PCMB INFORMATION

Discontinuation of FAN3 “3 wire” fan speed control mode

Version: V1.1

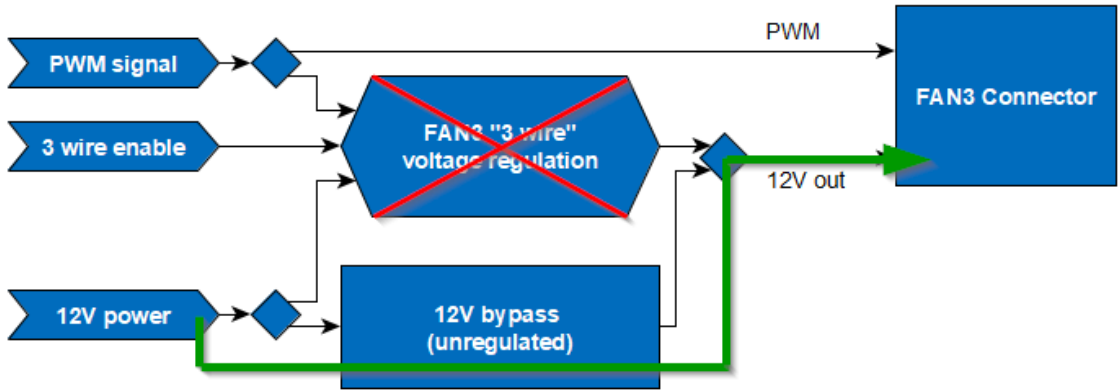
There will be no special BIOS version for boards with removed "3 wire" FAN regulation support. The corresponding BIOS option does not have any influence on these boards, even if you configure it to "3 wire"

- ✓ [Advanced > System Management > "FAN 3 Wiring"] -> set to "4 wires" (default)
